PLANNING AND ZONING CASE CHECKLIST

P&Z CASE # SP2018-006 P&Z DATE _____ CC DATE _____

MEMORANDUM

SUBJECT: SP2018-006; *White Tiger*

PROJ# 15072013
DATE JULY 7, 2013
DRY# 100
LANDSCAPE PLAN, PLANT LIST, & TABULATIONS
OWNER LP1.01

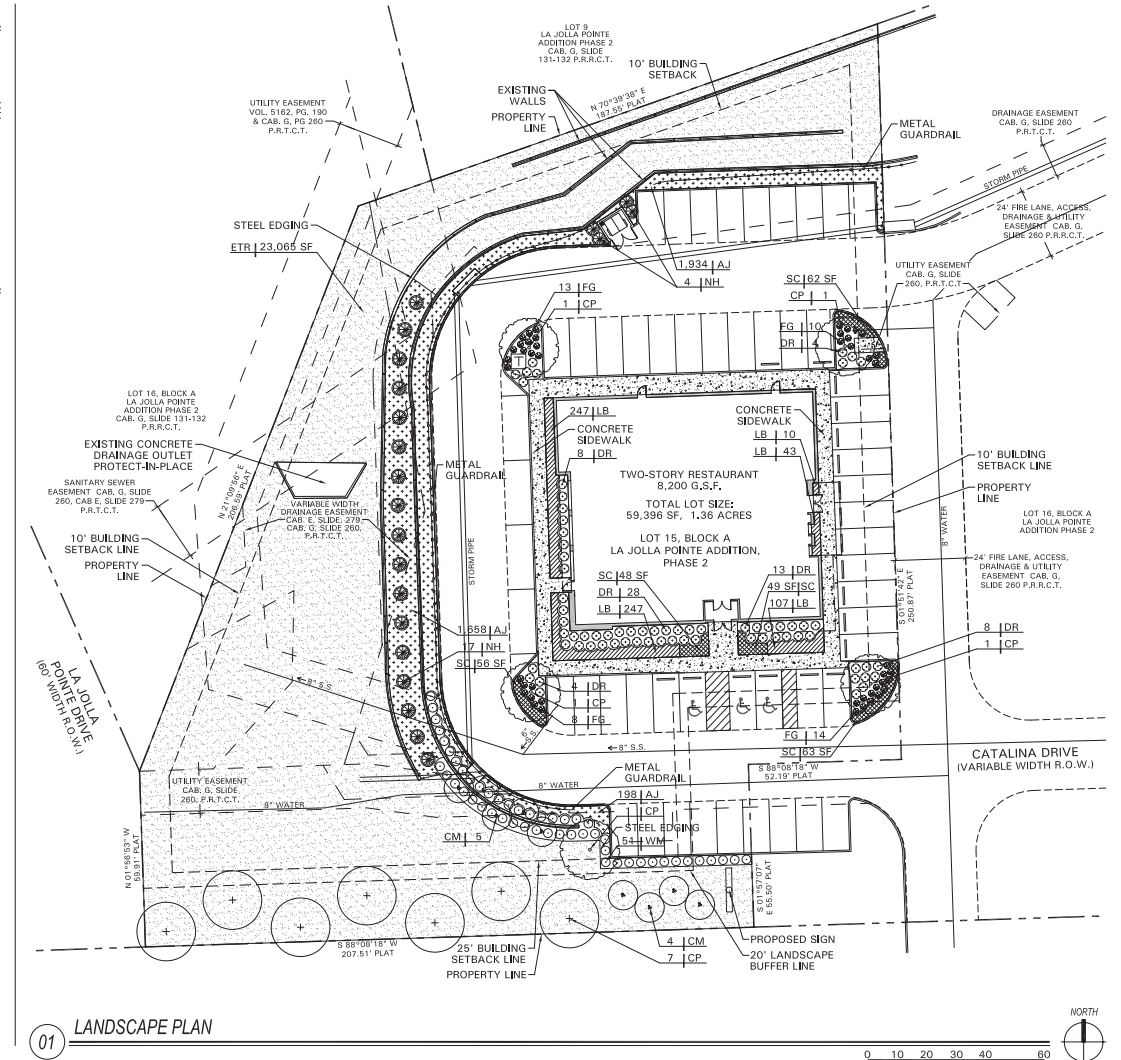
The applicant has submitted a landscape plan indicating an approximate total of 13% landscaping coverage for the site; however, when the existing turf is included in the calculation, the total landscaping for the site is approximately 51%. This amount will exceed the 15% minimum for a commercial development required by the Unified Development Code (UDC).

1. IH-30 OV district requires a minimum four (4) caliper inch canopy trees in the landscape buffer.
2. With the exception of the landscape buffer canopy trees, the remainder of the plan meets (or exceeds) the intent of the Unified Development Code as submitted.

© 2012 MERRIMAN ASSOCIATES ARCHITECTURE-PLANNING INTERIOR DESIGN
 PROJECT NUMBER: 2012067
 DATE: MAY 10, 2012
 SHEET TYPE: EXTERIOR ELEVATIONS NORTH/SOUTH
 SHEET: A3.01

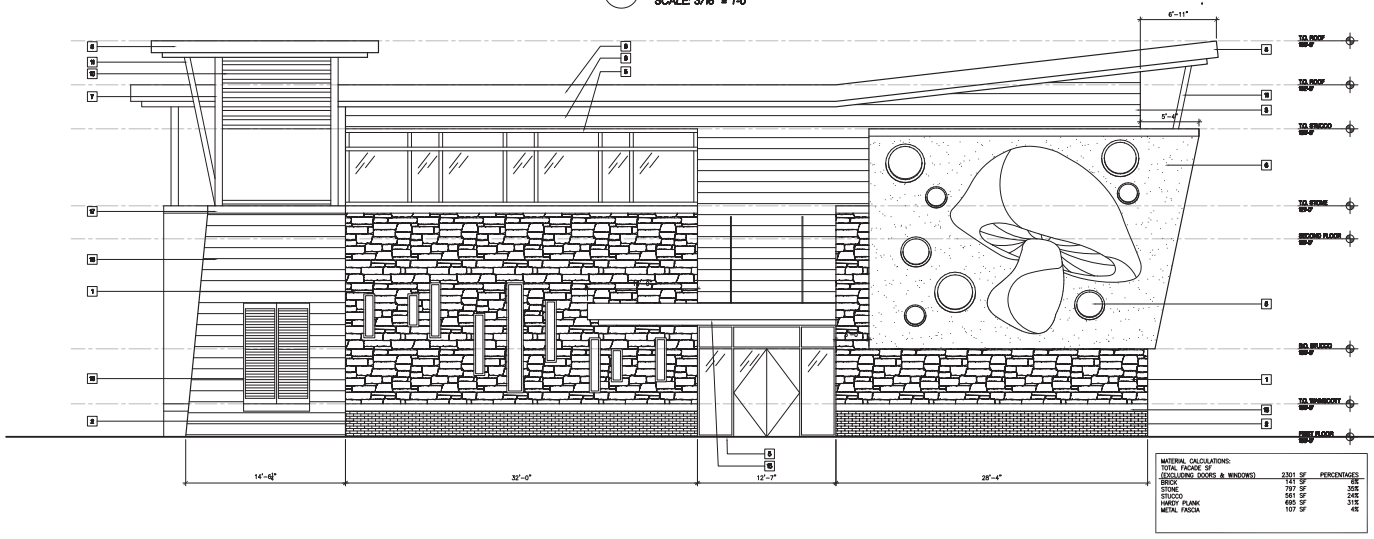
To be considered as included with the buildings elevation is the use of an artistic "mushroom" located on the south elevation. The mushroom is painted on an approximately 600 sq-ft stucco projection with varying sized decorative circular glass and stands seventeen (17) feet in height. Also to consider will be the wall signage and more specifically the corporate logo of a "mushroom character" on the east elevation. The logo stands at approximately fifteen (15) feet in height and is requested as a variance to the IH-30 OV districts sign requirements.

- 1) Wall signage and graphics as an artistic feature (as submitted), and
- 2) Not meeting the minimum 20% natural or quarried stone requirements for the north, east and west elevations.

- 1) Wall signage and graphics as an artistic feature (as submitted), and
- 2) Not meeting the minimum 20% natural or quarried stone requirements for the north, east and west elevations.

1. Masonry requirements,... Each exterior wall shall consist of 90 percent masonry materials,...on walls which are visible from a public street or open space, including a minimum of 20 percent natural or quarried stone.

It should be noted that similar variances to the masonry and signage requirements have been granted in the past. Staff feels the request to have merit and recommends approval of the variances.

1. The variances to the standards of the IH-30 Overlay district to allow for 1) Wall signage and painted graphics as an artistic feature (as submitted) and 2) Not meeting the minimum 20% natural or quarried stone requirements for the north, east and west elevations are to receive approval from City Council (requires a 3/4 majority vote of City Council for approval).
2. With the exception of the variances requested, the proposed building meets the intent of the Unified Development Code.
